Project: IEEE P802.15 Working Group for Wireless Personal Area Networks (WPANs)

Submission Title: [Radio Specification Analysis of Draft FSK PHY]

Purpose: [To assist with the definition of the 15.4k FSK PHY]

- Transmit spectral mask
- 25 kb/s M.I. = 1.0

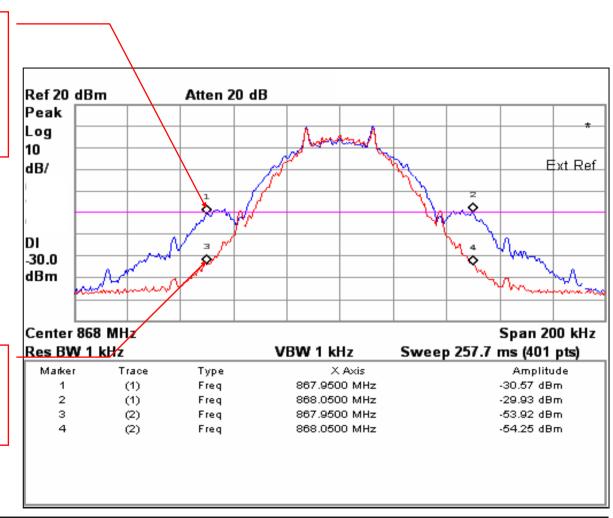
GFSK BT = 1.0 MKR 1, MKR 2 indicate nom. Mod BW limits for 100 kHz channel spacing MARGINAL COMPLIANCE

GFSK BT = 0.5 MKR 3, MKR 4 indicate compliance with ~20 dB margin

- Transmit spectral mask
- 12.5 kb/s M.I. = 4.0

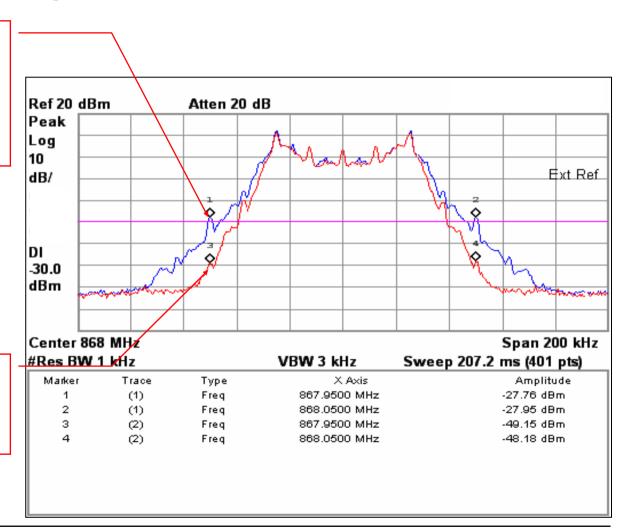
GFSK BT = 1.0 MKR 1, MKR 2 indicate nom. Mod BW limits for 100 kHz channel spacing MARGINAL COMPLIANCE

GFSK BT = 0.5 MKR 3, MKR 4 indicate compliance with ~20 dB margin

- Transmit spectral mask
- 37.5 kb/s M.I. = 0.5 (Silicon source)

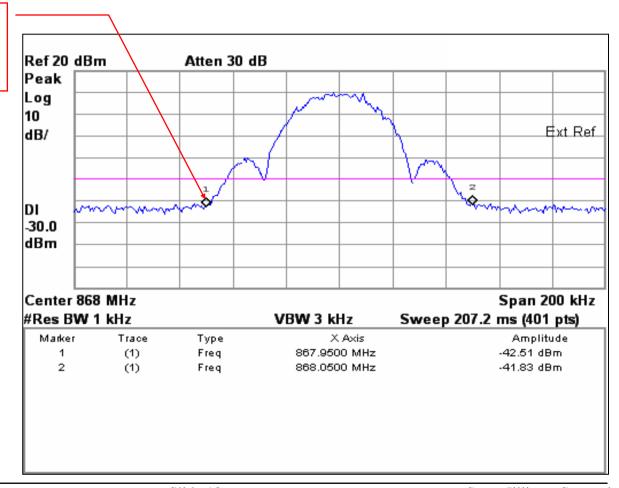
GFSK BT = 1.0 MKR 1, MKR 2 indicate ~10 dB margin!

- For 100 kHz / FHSS in Europe GFSK BT = 0.5 required
 - Increases system requirements on to receiver
- Define non-specific modulation case to allow mod. BW up to 300 kHz and implement frequency agility (AFA + LBT)
 - "Grey" area as to whether you can still define 100 kHz channel spacing
 - No consistent response based on Notified Body "interpretation"
- Standardize on 200 kHz channel spacing for sub-GHz FSK PHY channel spacing
 - 15.4g MR-FSK CSM
 - Define non-specific modulation case to allow mod. BW up to 300 kHz and implement frequency agility (AFA + LBT)
 - ETSI TG 28 looking at smart grid utilization in Europe and are taking reference from 15.4g FSK PHY proposals. Would fit some LECIM applications
- Define PHY more suitable for 100 kHz / FHSS operation
 - e.g. GFSK 12.5 kb/s, Mod. Index = 2.0, BT = 1.0

- Receiver interference rejection
 - Consider the case of 25 kb/s PHY (GFSK BT = 0.5) with a modulated interferer in the alternate channel

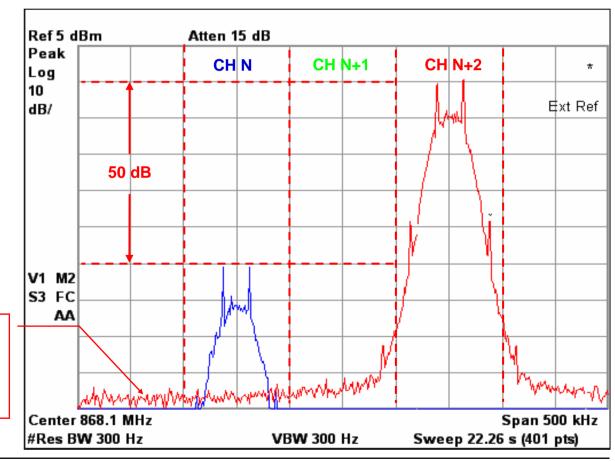
Phase noise of interferer (R&S SMIQ) bleeds into wanted channel
